## City of Sweet Home

### Staff Report Presented to the Planning Commission

**REQUEST:** The applicant is requesting to subdivide an approximately 13.37-acre site into 42 residential lots and four tracts including an existing single-family residential dwelling that will be retained with the proposed development. The subject property is to the northeast of the Zelkova Street and Clark Mill Road intersection and is identified by 1400 Clark Mill Road and Linn County Tax Assessor's Map No. 13S01E29 Tax Lot 3502. Lots sizes would range in size from 8,032 square feet to 12,290 square feet. All lots would be eligible to be developed with single, two-family, and/or single-family attached dwellings and accessory uses with approval of a conditional use permit allowing residential uses not related to or in conjunction with a recreational development [SHMC 17.60.030(D)]. The subject property is in the Recreation Commercial (RC) Zone.

**FILE NUMBER:** SD22-01

PRELIMINARY STORM DRAIN PLAN

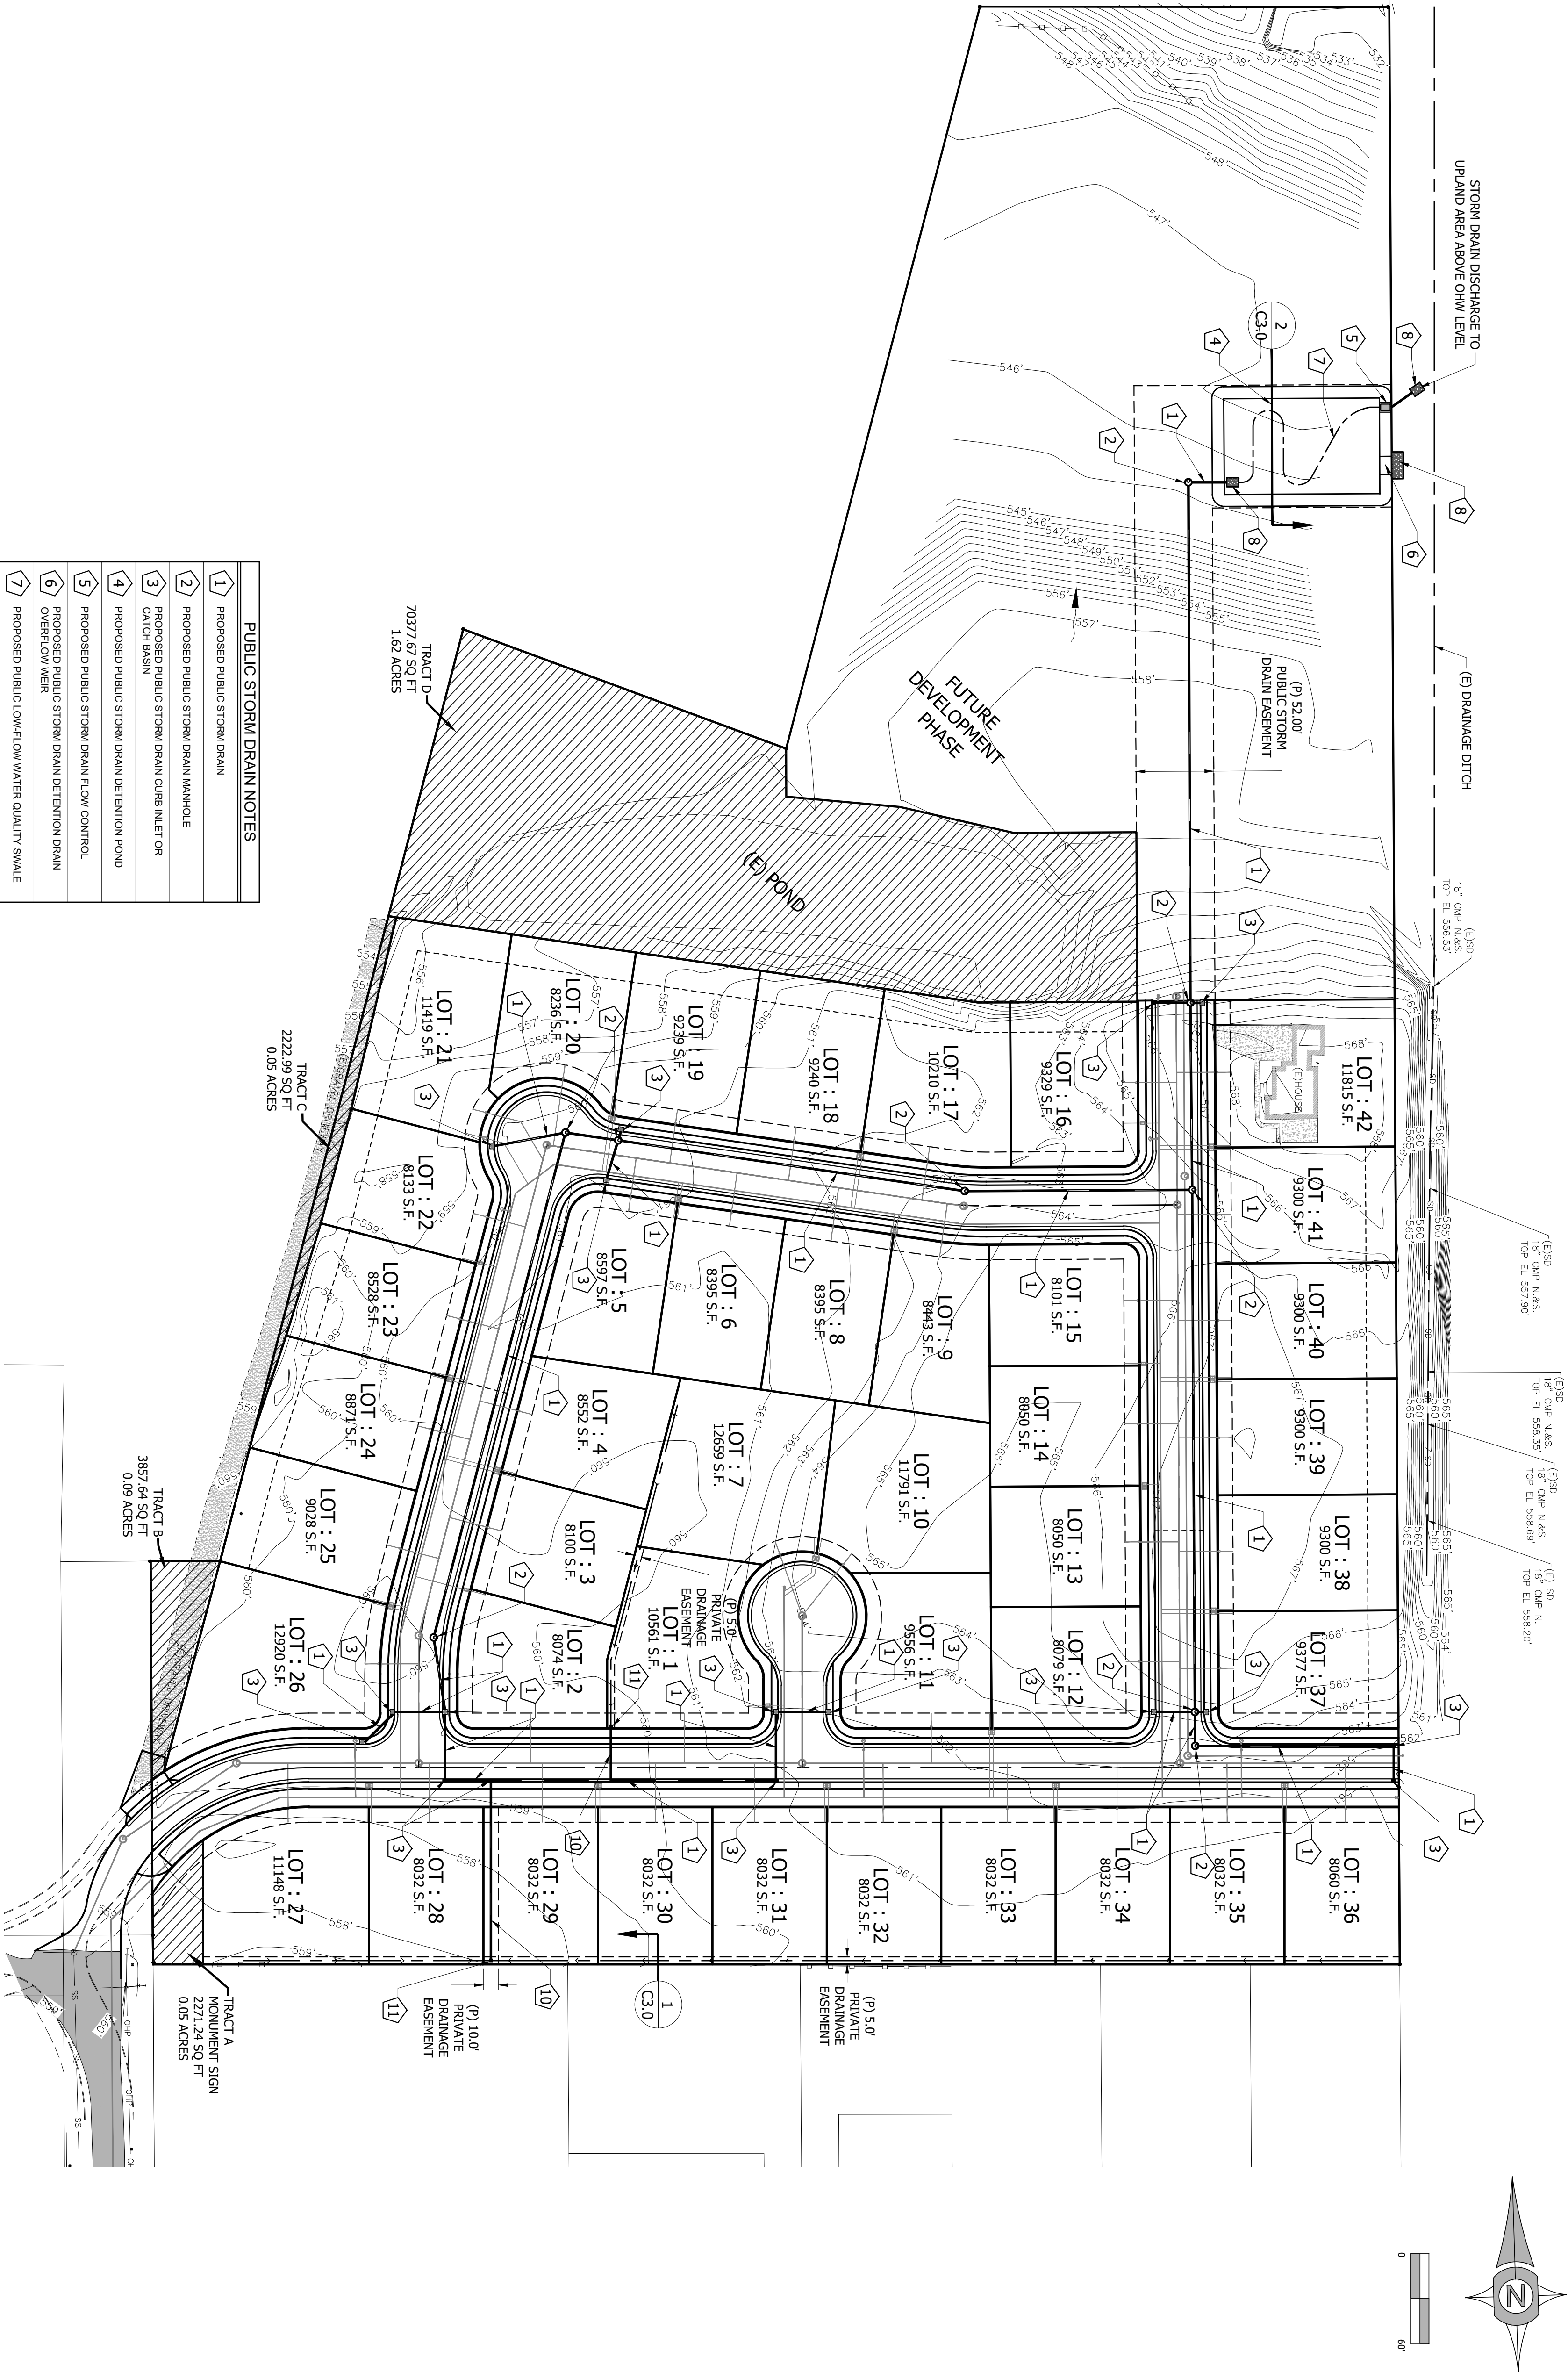
Drainage: The detention pond is located in the future development phase area. Developer shall indicate what will happen to the detention pond during the future development phase (i.e. protect it, expand it to serve phase 2, etc). The detention pond is proposed to be public. City standard is that detention ponds to serve developments are private. However in this case the City may wish to discuss with the developer an option incorporating the detention pond into a City park. PW Maintenance has indicated a willingness to maintain the pond if it is part of a City park. CEDD should evaluate whether the creation of a neighborhood park in this vicinity is consistent with the Parks Master Plan. The outfall from the pond crosses onto adjacent property 13S01E28 00700 which is also owned by the applicant. A utility easement is recommended (or may be required, I am not sure) to prevent any disputes with future property owners in perpetuity. The utility easement to the pond has a dropoff with approx. 20% slope. The developer shall grade the easement to reduce the slope and base rock it to provide vehicle & equipment access to all pipes & appurtenances. I recommend constructing the access in accordance with road base requirements so that it won't have to be rebuilt in the future when the road is extended to the future development phase. Reference AASHTO A Policy on Geometric Design of Highways and Streets, 2011 6<sup>th</sup> Ed section 5.3.1, "Grades for local residential streets should be as level as practical, consistent with the surrounding terrain. Grades for local residential streets should be less than 15 percent." (The 2011 6<sup>th</sup> Edition is the newest edition the City has access to; the 2018 7<sup>th</sup> Edition is the current edition which should be used for design.)

13. The applicant shall grade the utility easement to the pond (Tract D) to reduce the slope and base rock the easement to provide vehicle and equipment access to all pipes and appurtenances.

Tee  
intersection

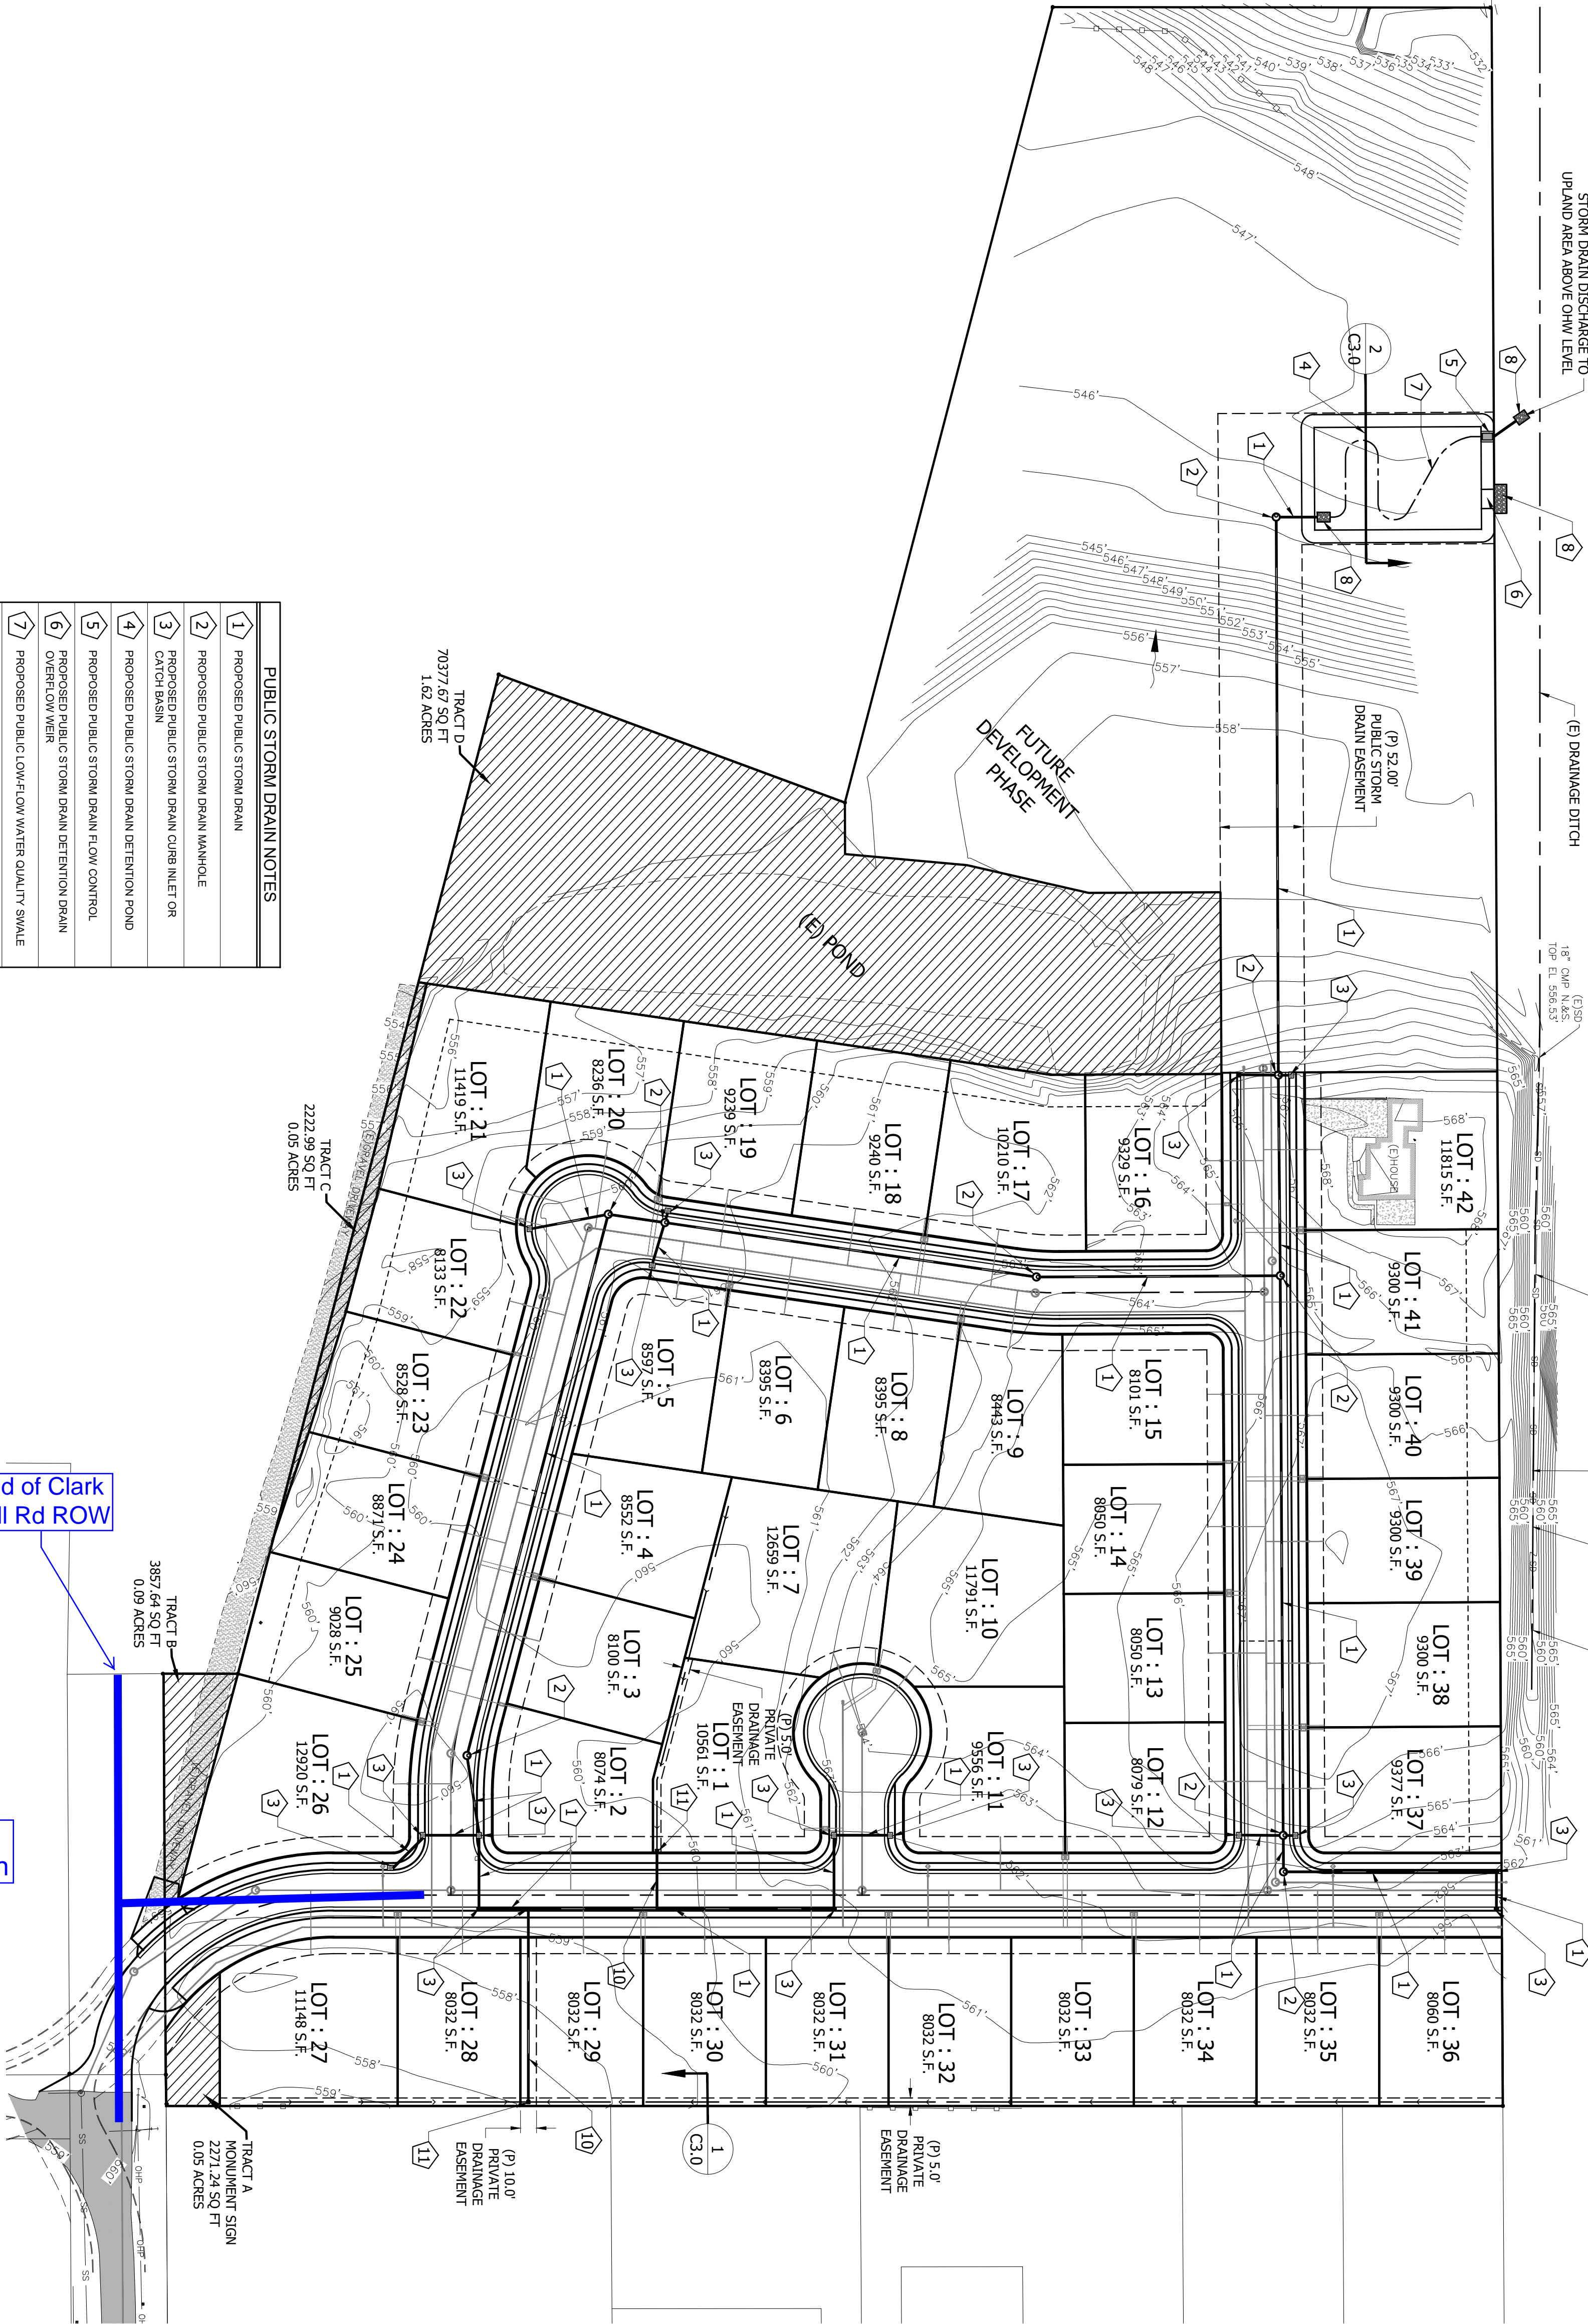
**Public Works Dept.:** Streets: The Clark Mill Rd right-of-way extends north beyond the street connection and provides frontage to the Tack property, 13S01E29 03501. The street connection with Clark Mill Rd shall be a tee intersection, not a curve as drawn, to provide for future roadway extension to any future developments of the Tack property. See attached figure. Street improvements on Clark Mill Rd are required from the development to Zelkova St. The planned development will need to incorporate a street naming system beyond Z. Reference SHMC 12.20.030 System of Naming Streets.

Per the Public Works comments in Section II: The Clark Mill Road right-of-way extends north beyond the street connection and provides frontage to the Tack property, 13S01E29 03501. The street connection with Clark Mill Road shall be a tee intersection, not a curve as drawn, to provide for future roadway extension to any future developments of the Tack property. (see Attachment D). Street improvements on Clark Mill Road are required from the development to Zelkova Street. The planned development will need to incorporate a street naming system beyond Z. Reference SHMC 12.20.030 System of Naming Streets.

6. The applicant shall provide a tee intersection at the intersection of Clark Mill Road and the entrance to the subdivision (see Attachment D).
7. The applicant shall provide street improvements on Clark Mill Road from the development to Zelkova Street.
